Project	IEEE 802.16 Broadband Wireless Access Working Group < http://ieee802.org/16 >
Title	Reliable Transmission for Critical MAC Management Messages
Date Submitted	2008-03-10
Source(s)	Yih-Shen Chen, I-Kang Fu, Kelvin Chou, Dora Chen and Paul Cheng yihshen.chen@mediatek.com IK.Fu@mediatek.com Paul.Cheng@mediatek.com MediaTek Inc. No.1, Dusing Rd. 1, HsinChu Science-Based Industrial Park, HsinChu, Taiwan
Re:	IEEE 802.16m-08/005, "Call for Contributions on Project 802.16m System Description Document (SDD)". In response to the following topics: <ul style="list-style-type: none"> •comments on the content of section 8
Abstract	This contribution discusses the benefit of MAC management messages over ARQ/HARQ channel for IEEE 802.16m system
Purpose	For discussion on the transmission of MAC management message issue and adoption on proposed text modification to SDD by TGM
Notice	<i>This document does not represent the agreed views of the IEEE 802.16 Working Group or any of its subgroups. It represents only the views of the participants listed in the "Source(s)" field above. It is offered as a basis for discussion. It is not binding on the contributor(s), who reserve(s) the right to add, am

Figure 2 The IEEE 802.16m MS/BS Control Plane Processing Flow

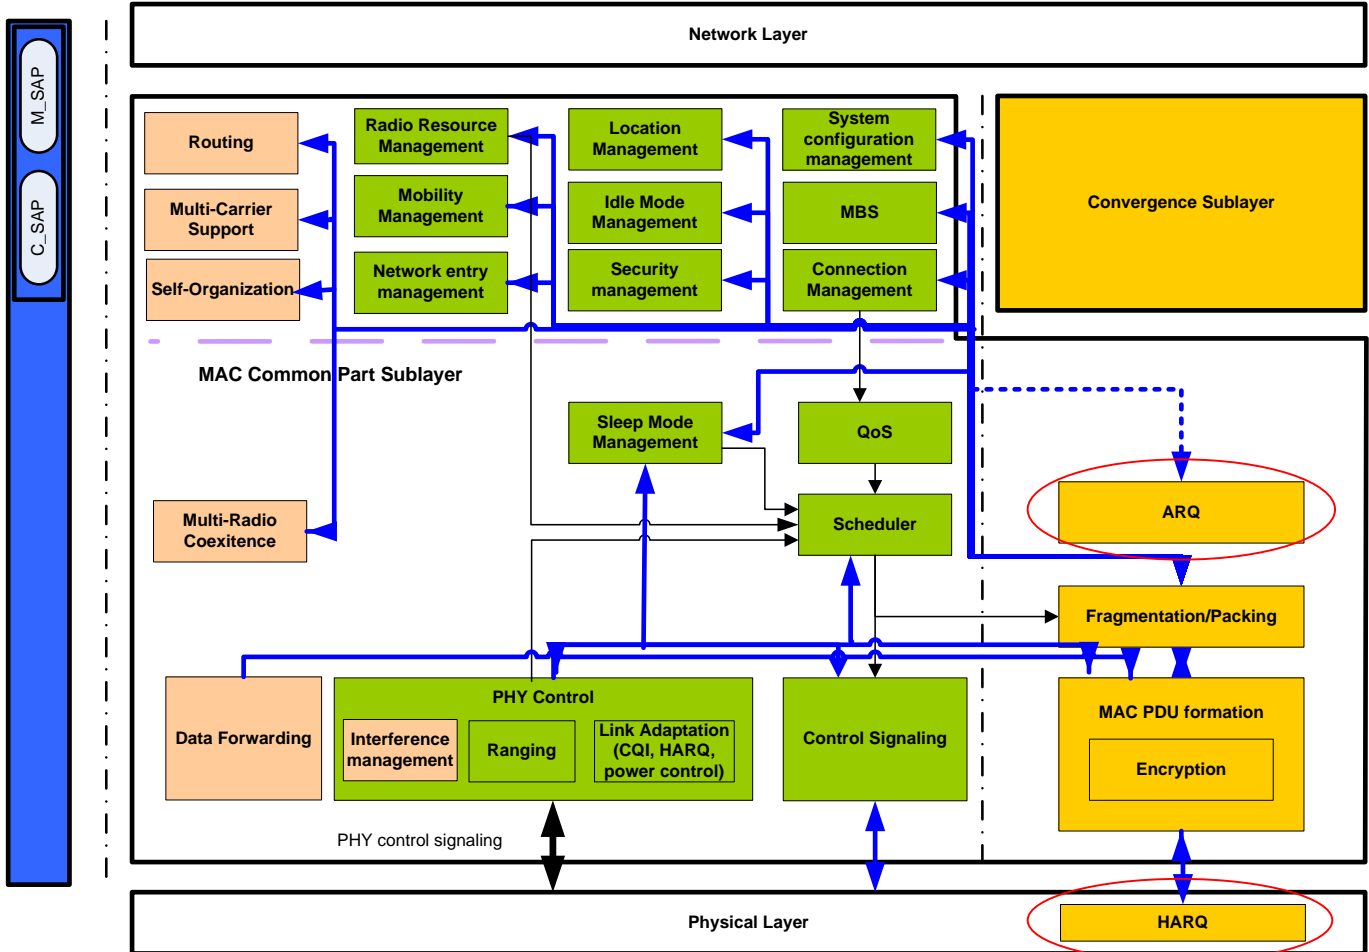
Both ARQ and HARQ can provide reliability for data transmission. HARQ scheme performs better than ARQ one because it employs the benefit of soft-combining. It provides a fast retransmission method when the received HARQ sub-burst cannot be correctly decoded and the corresponding NACK message is received by the sender. For MAC management messages requiring packet error rate of 10^{-3} , HARQ ensure enough reliability. But, for those messages requiring packet error rate of 10^{-6} , ARQ/HARQ-enabled transmission is recommended [4]. ARQ could further enhance the transmission reliability when HARQ does not work properly. There is a maximal retransmission count for each HARQ sub-burst. When the upper bound is reached, the HARQ sub-burst is discarded. Therefore, a stall problem would incur if the MAC management messages are segmented. That is, some segments of the MAC message are discarded by the HARQ sender if their retransmission exceeds the upper threshold. To solve it, HARQ receiver could detect the stall problem by a timer and employ a go-back-one ARQ mechanism for fast MAC-level retransmission. Therefore, we suggested that go-back-one ARQ in conjunction with HARQ is used for time-critical MAC management messages.

The other benefit is that, with the ARQ/HARQ-enabled mechanisms, the sender can make sure that the MAC message is correctly received by the receiver. Without the acknowledgement from the receiver, the sender and receiver may operate in different direction. This is important for handover operation. For example, problems of the lost of handover message were reported in [6]. When MS sends MOB_HO-IND to cancel the handover operation and serving BS (SBS) does not correctly receive it, MS goes back to the normal operation but SBS stops the resource scheduling for the MS. Additional complicated MAC procedures are required to solve this kind of problem. Obviously, it would not happen in the ARQ/HARQ-enabled transmission.

Fig 9: The IEEE 802.16m MS/BS Control Plane Processing Flow

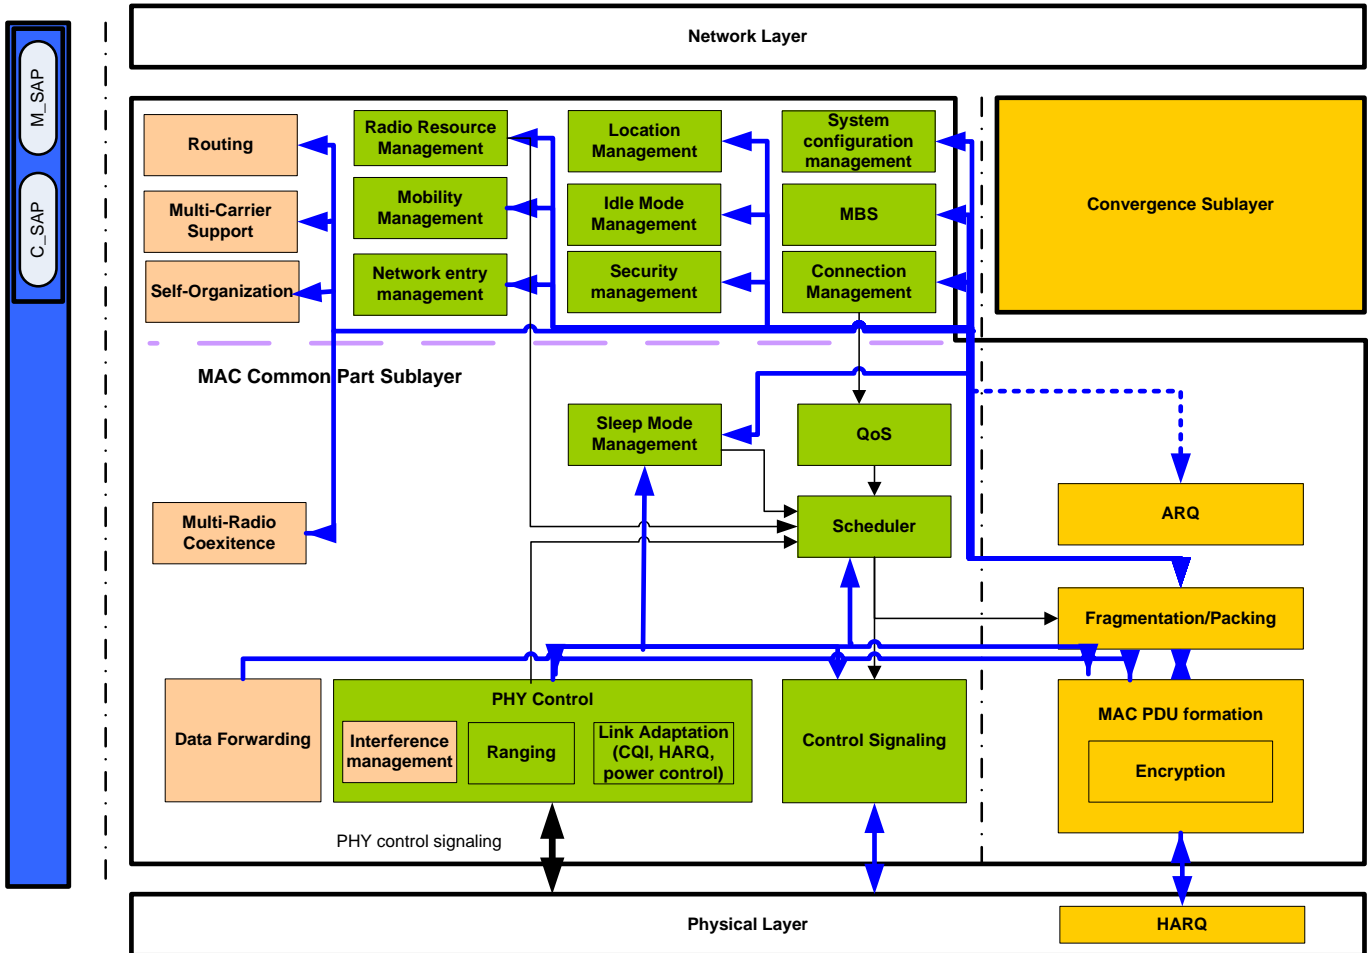
The following figure shows the MAC CPS control plane signaling flow and processing at the BS and the MS. On the transmit side, the blue arrows show the flow of control plane signaling from the control plane functions

to the data plane functions and the processing of the control plane signaling by the data plane functions to form the corresponding MAC signaling (e.g. MAC management messages, MAC header/sub-header) to be transmitted over the air. For critical MAC messages, they are transported over ARQ/HARQ channels to maintain high transmission reliability.....

[Replace Fig. 9 by the following figure]
